ZONE 7 WATER AGENCY
ALAMO CREEK BANK STABILIZATION AND FLOOD MANAGEMENT PILOT PROJECT
DUBLIN, CALIFORNIA
Project 306-24
ADDENDUM NO. 2
May 1, 2025

This Addendum No. 2 ("Addendum") is dated May 1, 2025, and modifies certain Bidding Documents issued by the Alameda County Flood Control and Water Conservation District, acting by and through its Zone 7 Water Agency ("District") in connection with the District's project: *Alamo Creek Bank Stabilization and Flood Management Pilot Project*. All capitalized terms not otherwise defined herein shall have the meanings provided in the Bidding Documents. There are no amendments other than Addendum 1, and Addendum 2. The bid submission date remains unchanged.

SHEET NO. C3B

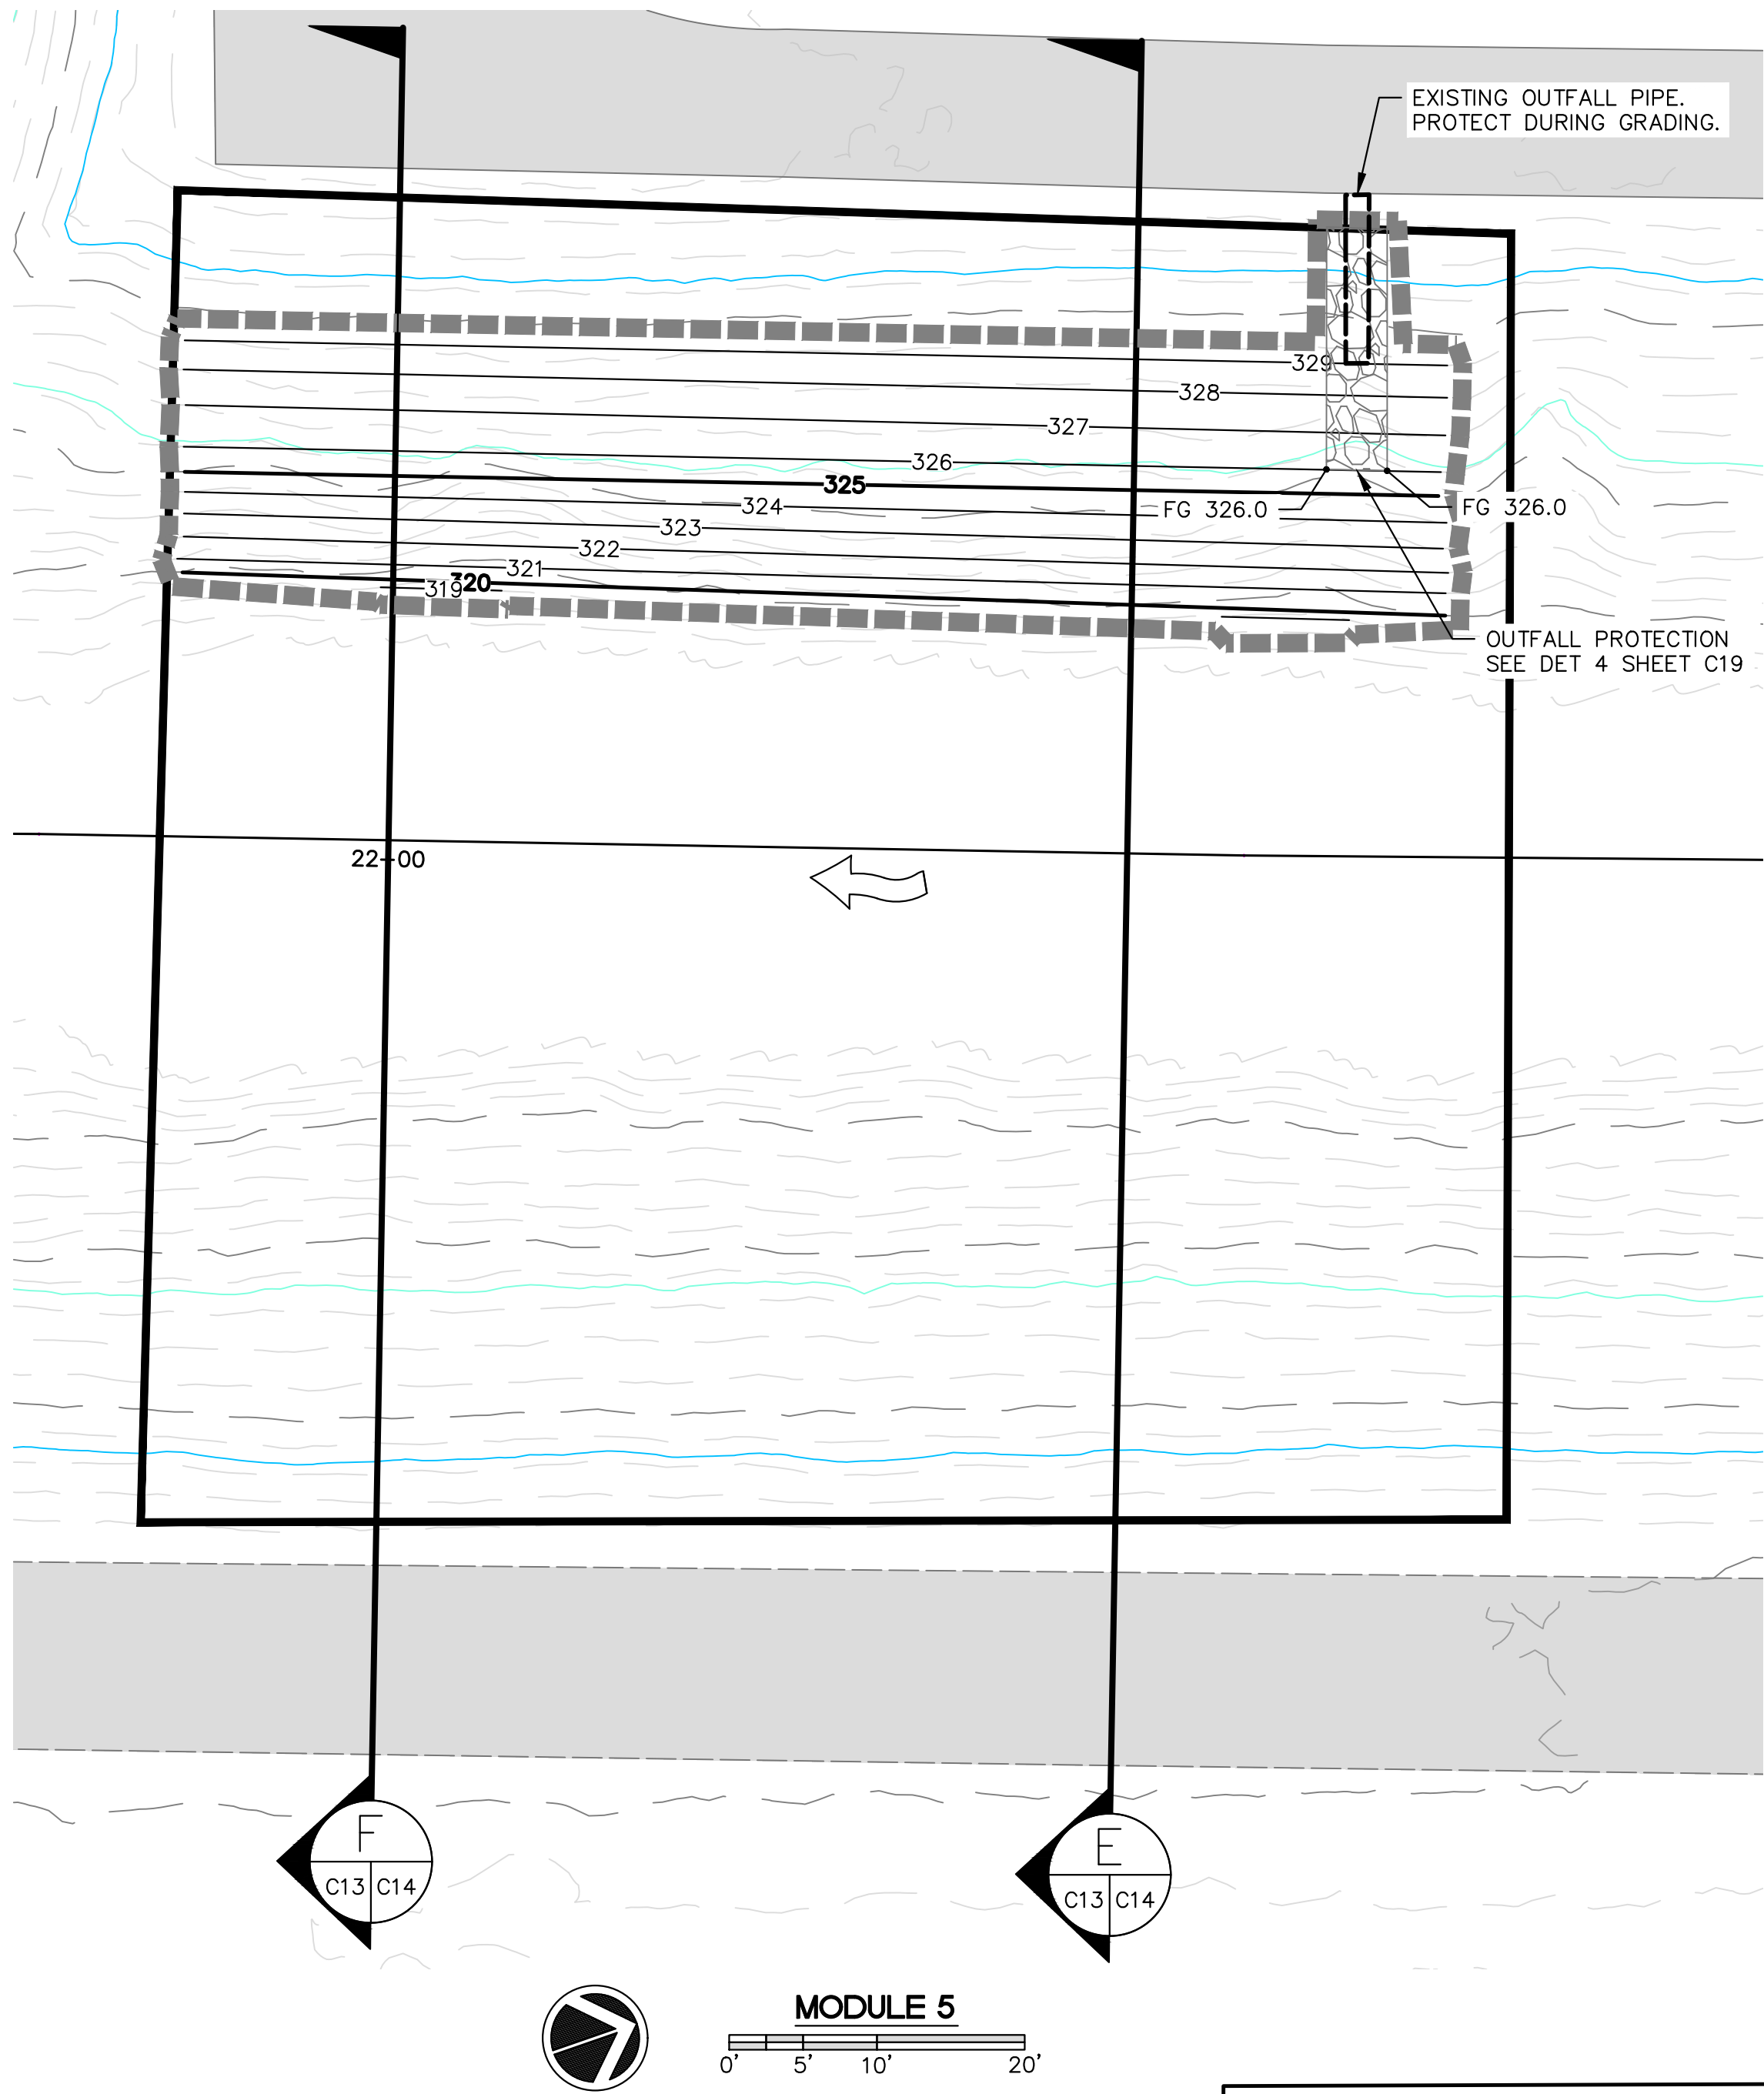
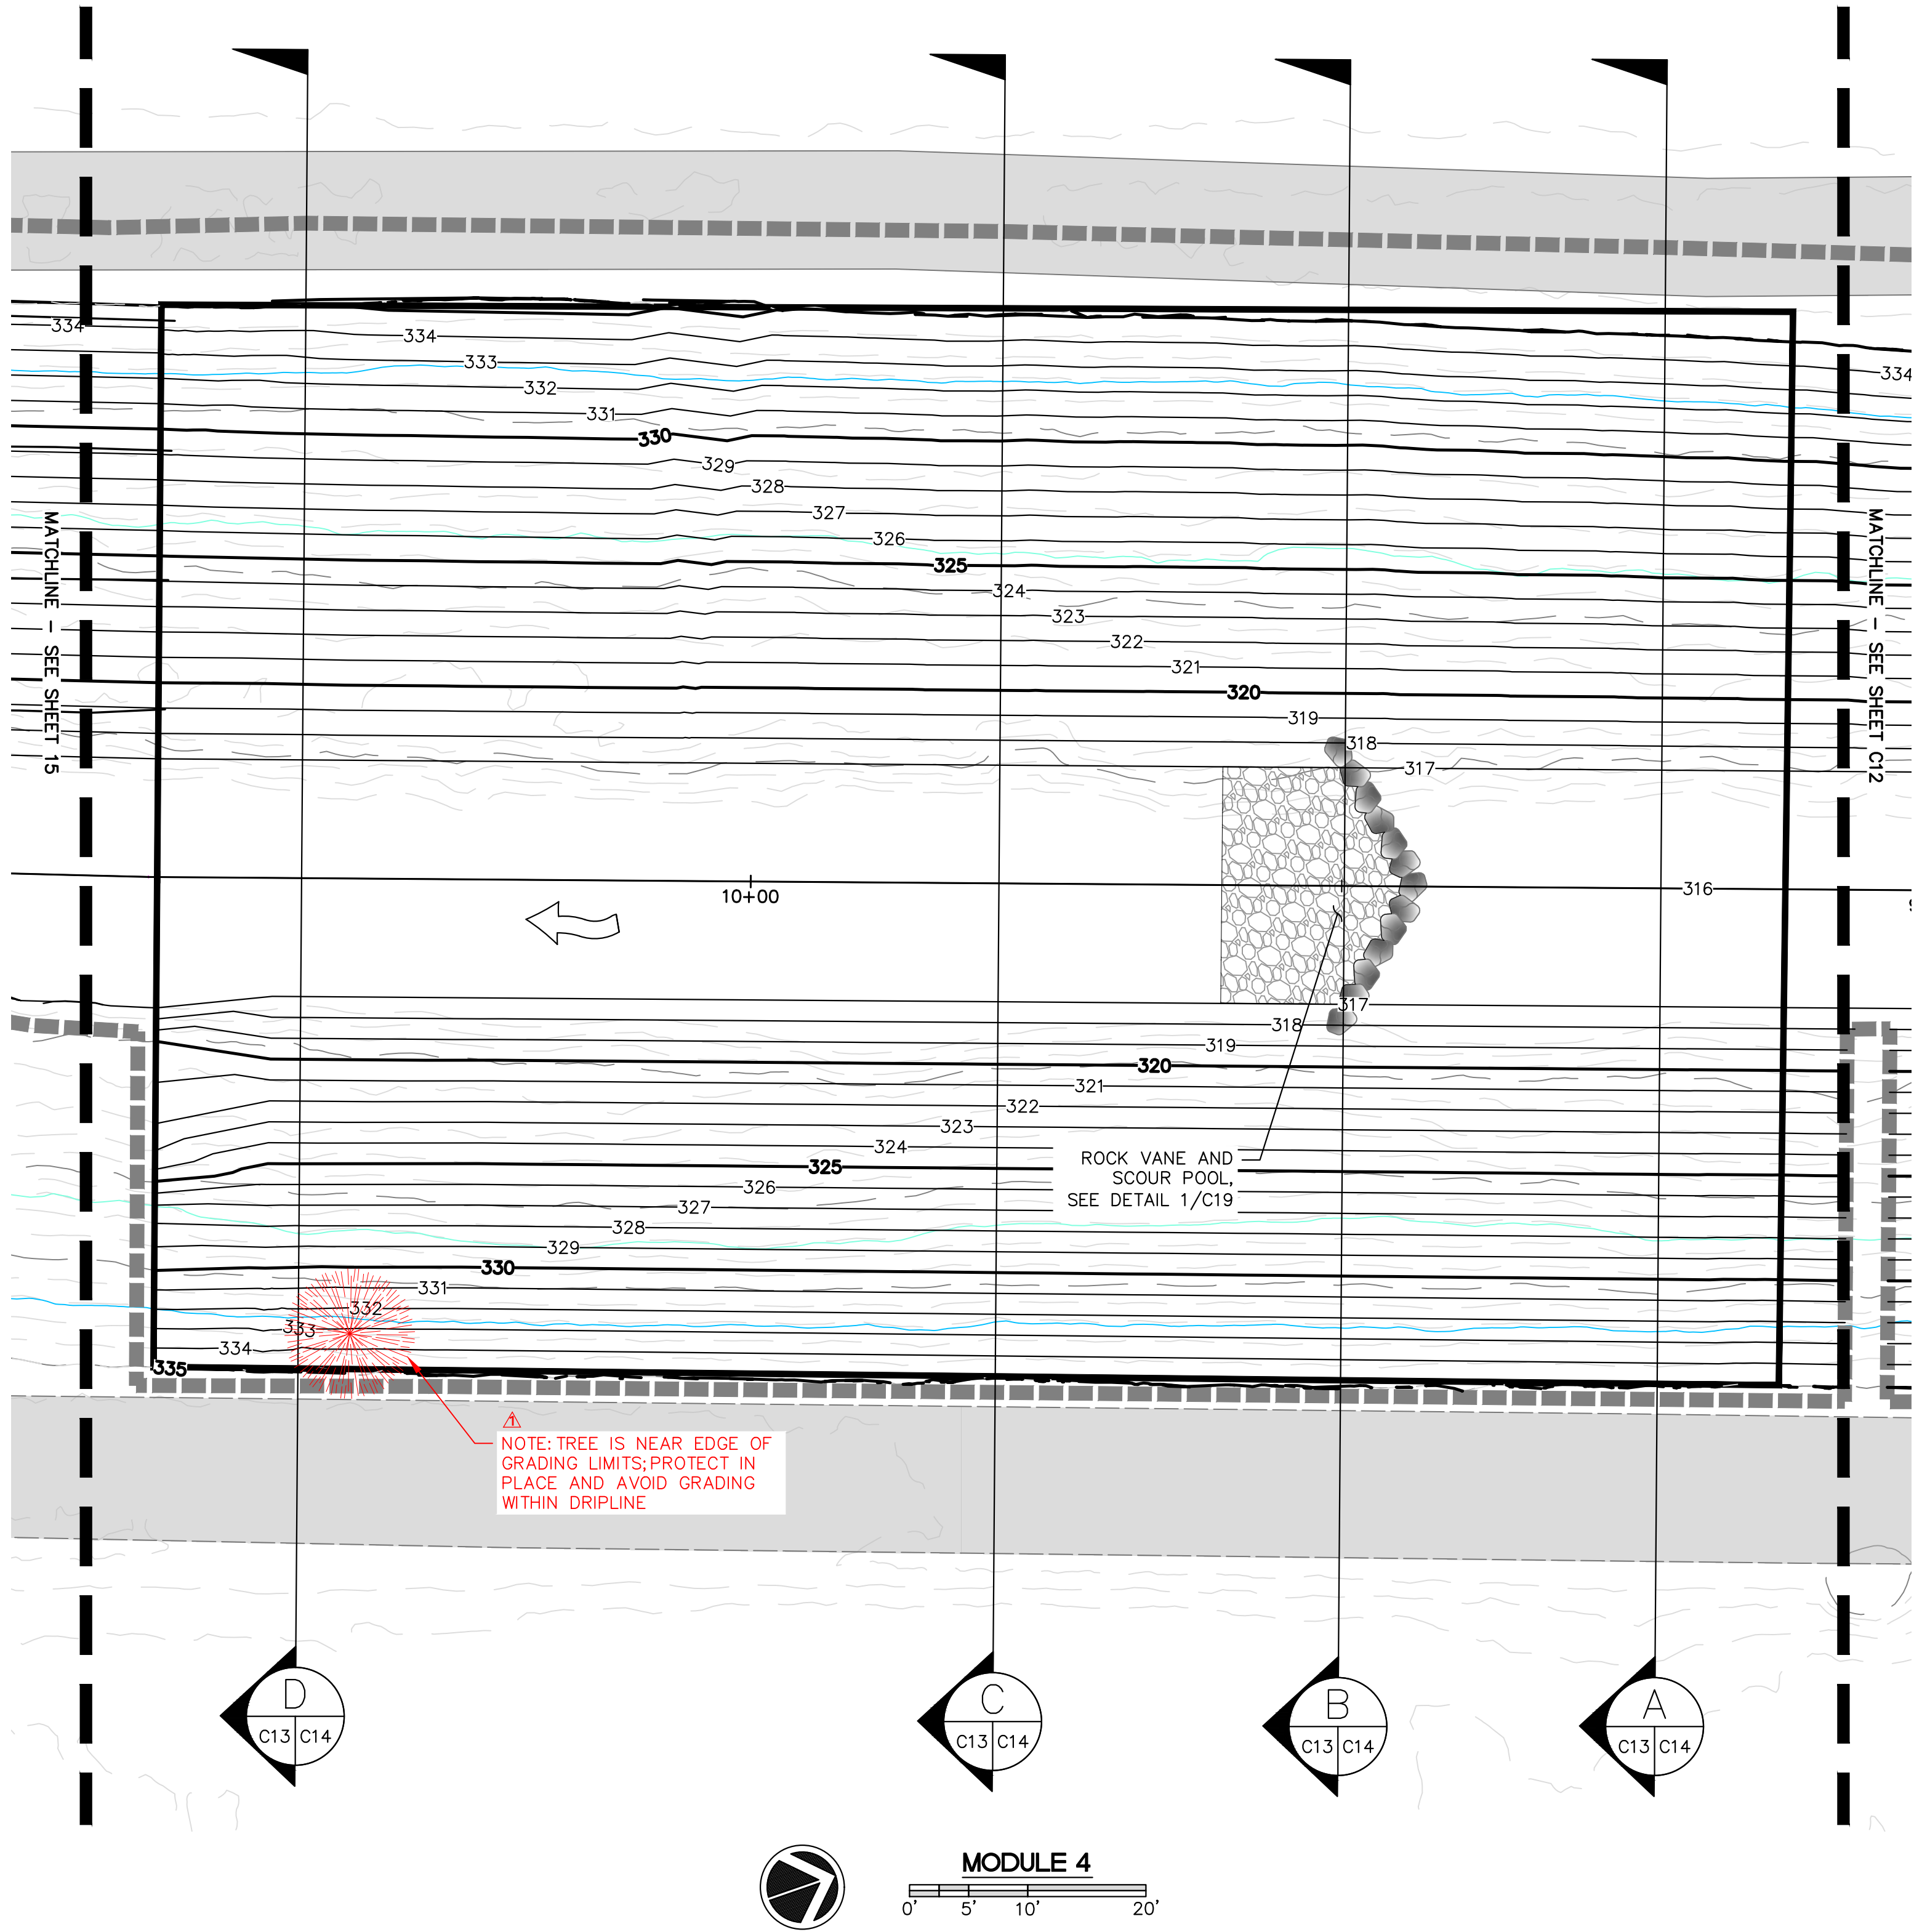
REVISION NO.	DATE	DESCRIPTION
1	04/22/2025	AMENDMENT 2: ADDED PROTECT IN PLACE INSTRUCTIONS FOR TREE
